RE: Surface Mining Interagency Committee

Enclosed please find written findings for Consolidation Coal Company, Burning Star #4 Mine, surface coal mining and reclamation operations permit application #152. Under Rule 1786.23(d) this is considered the Department's final action.

Results of Review of  
Permanent Program Permit Application #152,  
Consolidation Coal Company, North Field/East  
Burning Star #4, SM-1 Application

FIG.  
5 D-2

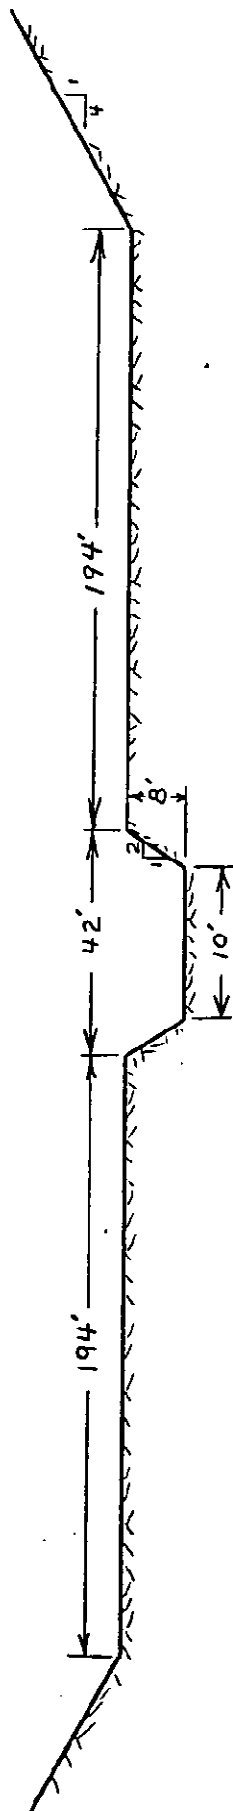
- 54) In order to ensure that the application is accurate and complete as required by Rule 1786.19(a), Table 5D-3 must be relabeled as "depths" and Figure 5D-2 needs revision to show channel depth and to change bottom width from 20 feet to 10 feet.
